RE: HOTEL DURELL FINAL EIR ADDENDUM

Appendix A:
Traffic Study Consistency Review for the Hotel Durell Site Driveway Adjustments

Date: July 19, 2018
To: Mark Brodeur, City of Pacific Grove
From: Robert Del Rio, T.E.
Subject: Traffic Study Consistency Review for the Hotel Durell Site Driveway Adjustments

Figure 2
Alternative Fountain Avenue Access

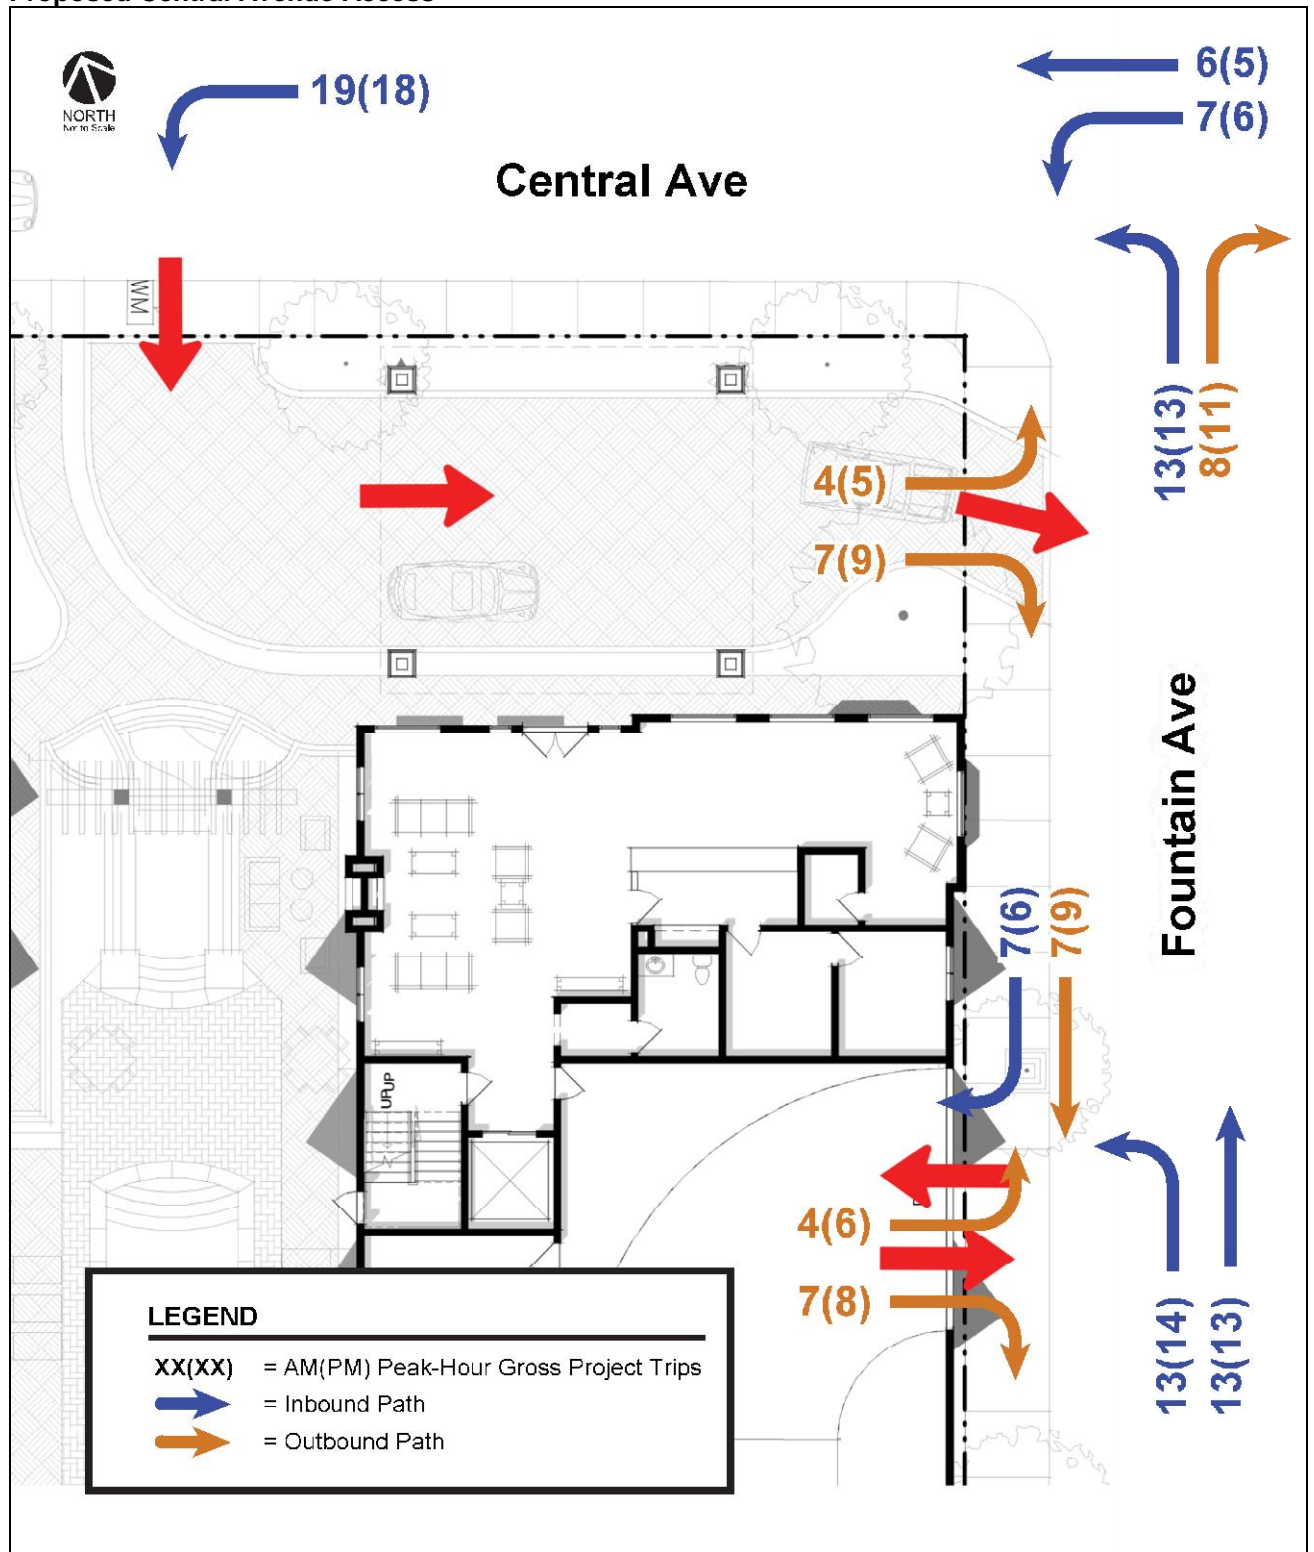
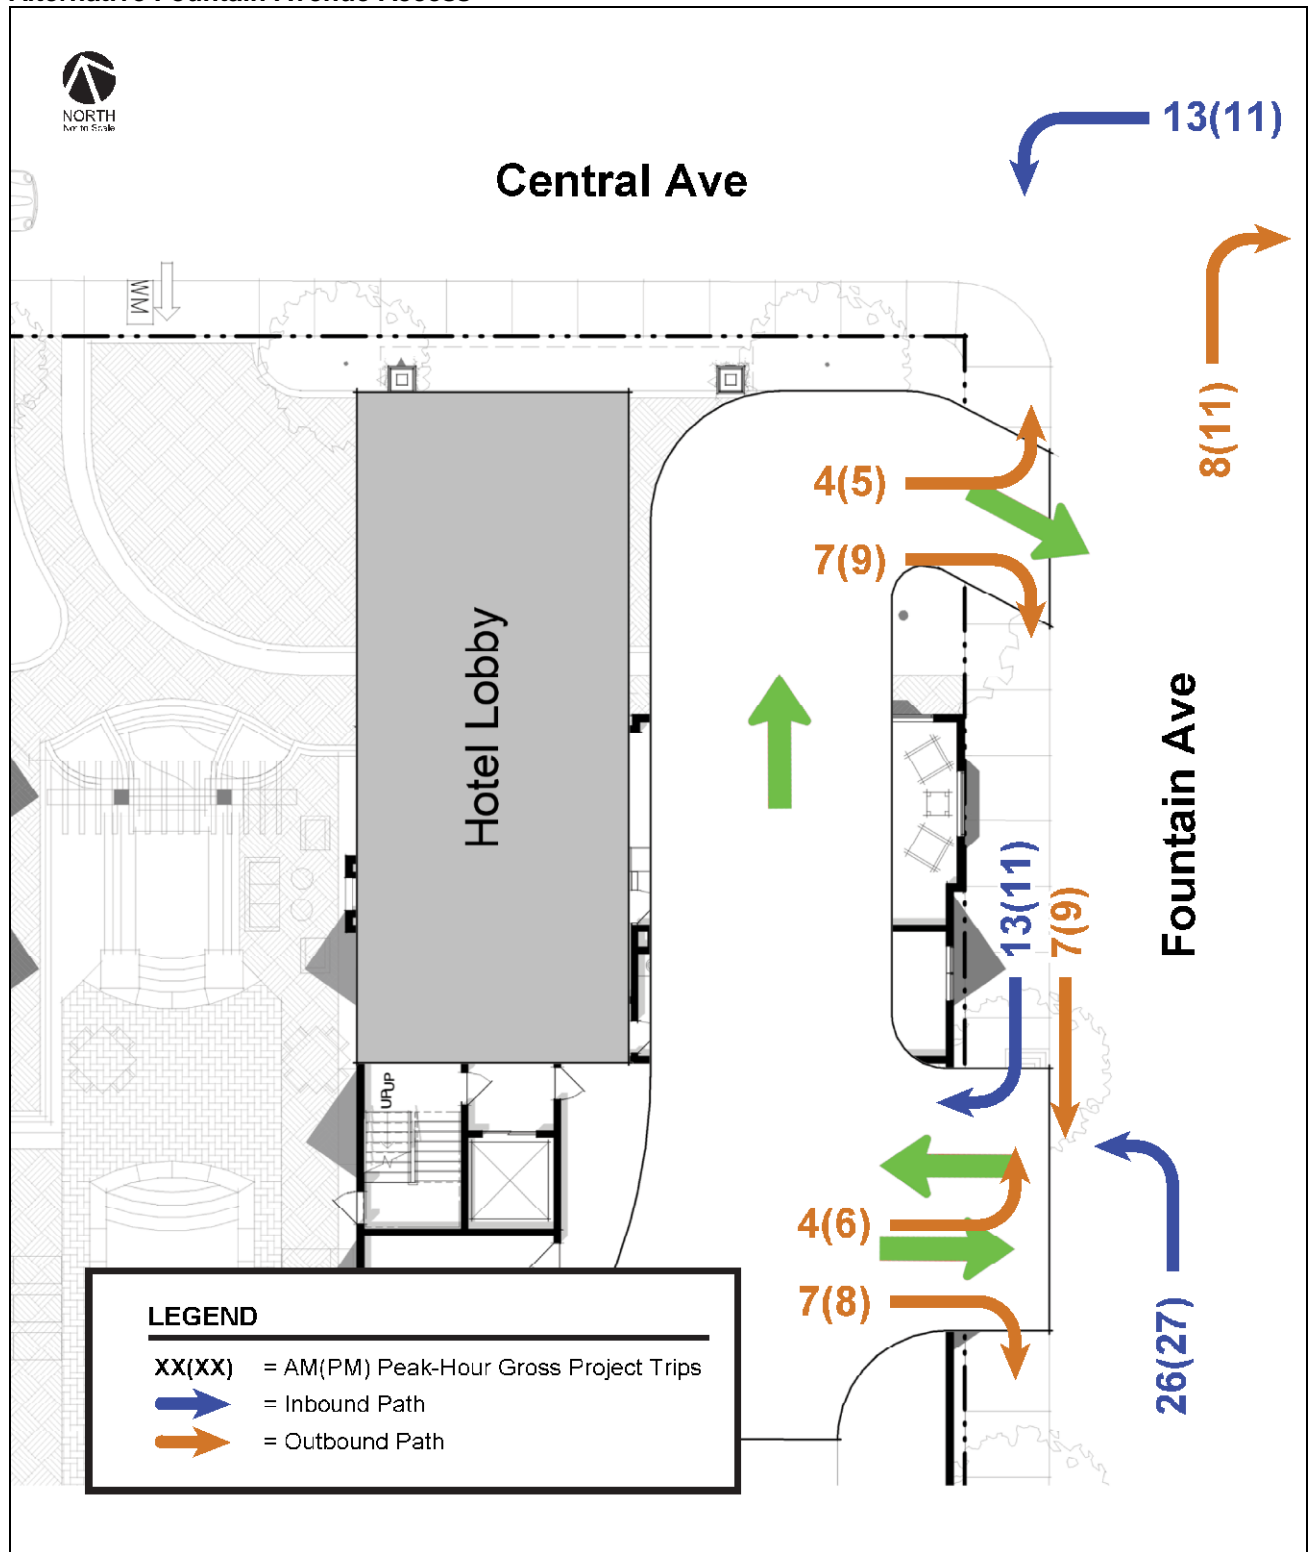
Proposed Central Avenue Access – The access as considered within the completed traffic study. Access to the main hotel entrance will be provided via one driveway along Central Avenue with exit out to Fountain Avenue. Access to the below grade parking lot and on-site valet parking would be provided via one inbound/outbound driveway along Fountain Avenue (see Figure 1).

Alternative Fountain Avenue Access – The main entrance and driveway along Central Avenue would be eliminated. Instead access to the parking garage and valet parking would be provided exclusively from Fountain Avenue with two exit driveways (see Figure 2).

Note that the City has deemed the Central Avenue exit alternative to be undesirable due to its conflict with pedestrians/bicyclists along Central Avenue. Therefore, only the Fountain Avenue access alternative is evaluated within this analysis.

Therefore, it can be concluded that the potential access adjustments of would not result in a significant change to the intersection operations that were reported in the completed traffic study for the proposed hotel.

Figure 3
Peak Hour Intersection Volume Comparison

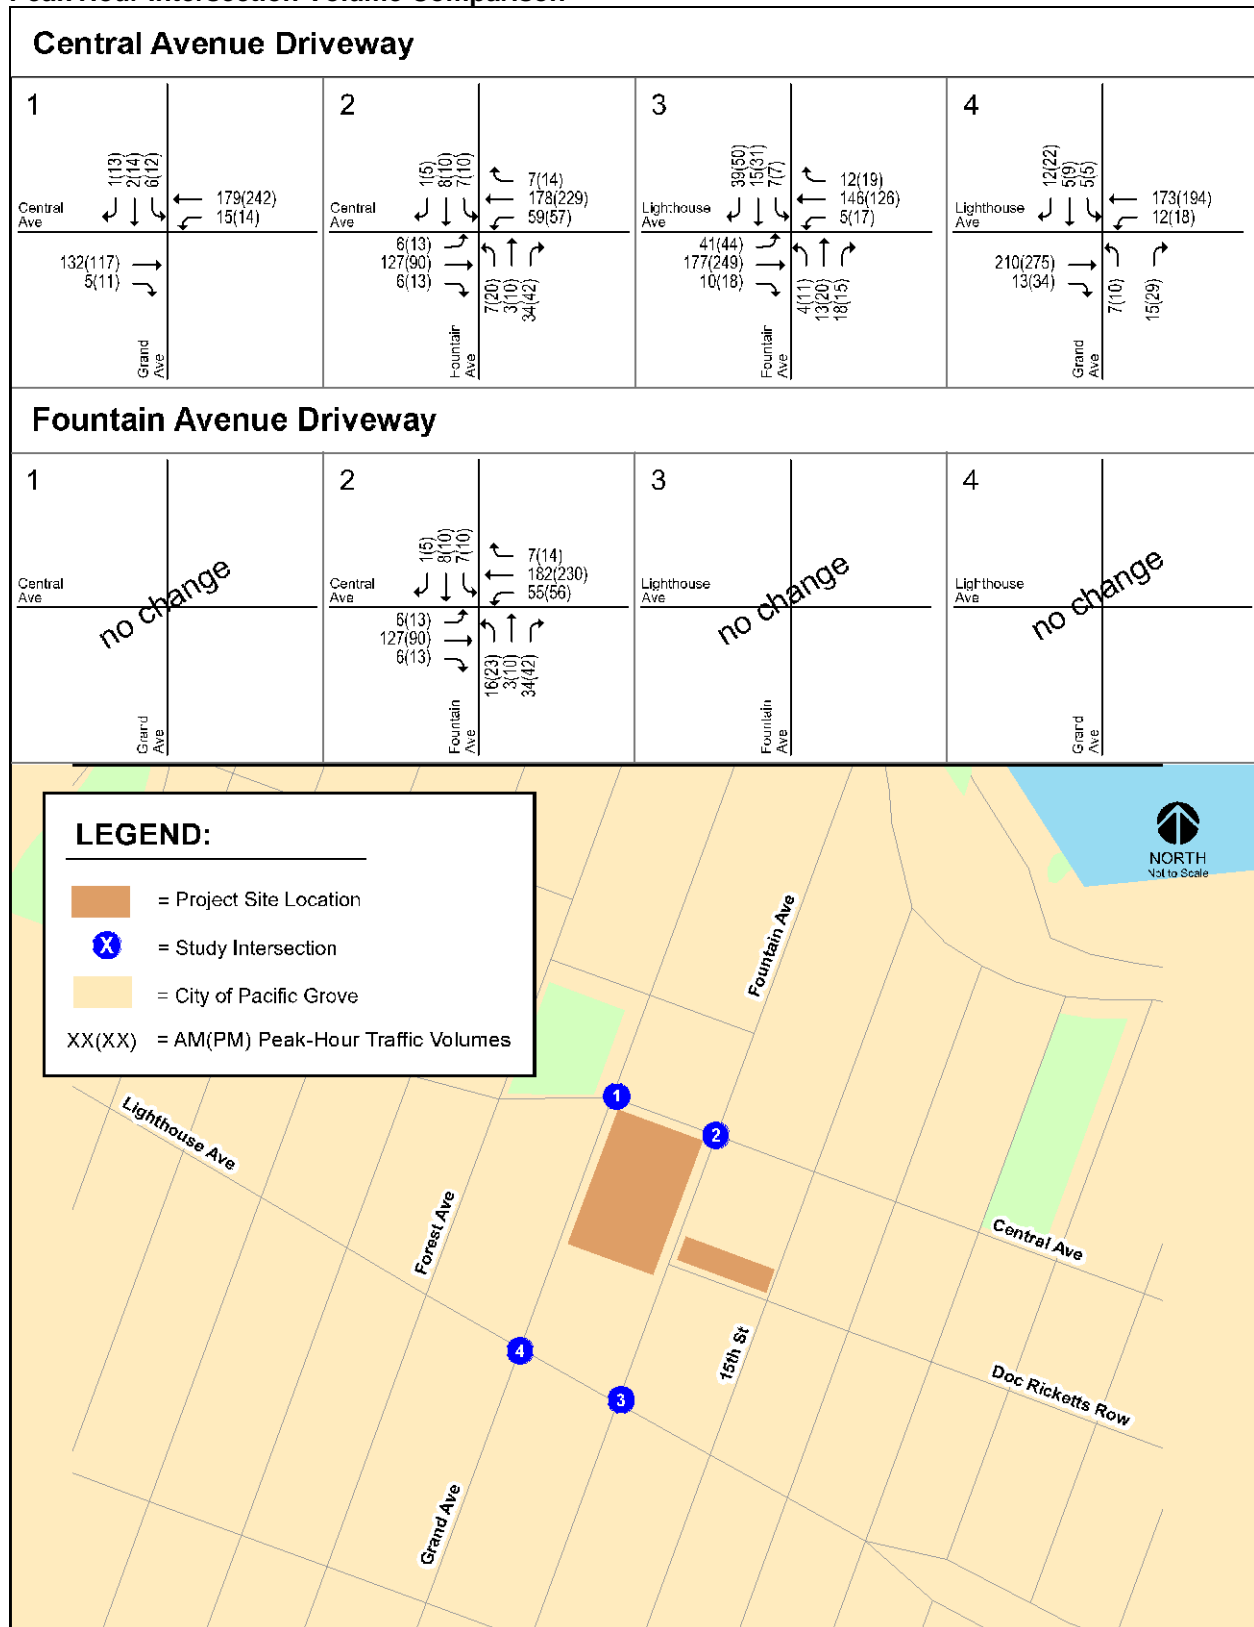
The completed traffic study included peak hour intersection level of service analysis at four intersections surrounding the project site. The level of service analysis is based on existing and estimated project peak hour traffic volumes. The elimination of the Central Avenue driveway associated with the Fountain Avenue access alternative will have minimal effect on traffic patterns of the proposed hotel. In fact, the adjusted access would result in changes to only one of the four intersections included in the traffic study, Central Avenue and Fountain Avenue. A comparison of peak hour intersection turn-movements for the proposed Central Avenue access and Fountain Avenue access alternative is shown in Figure 3.
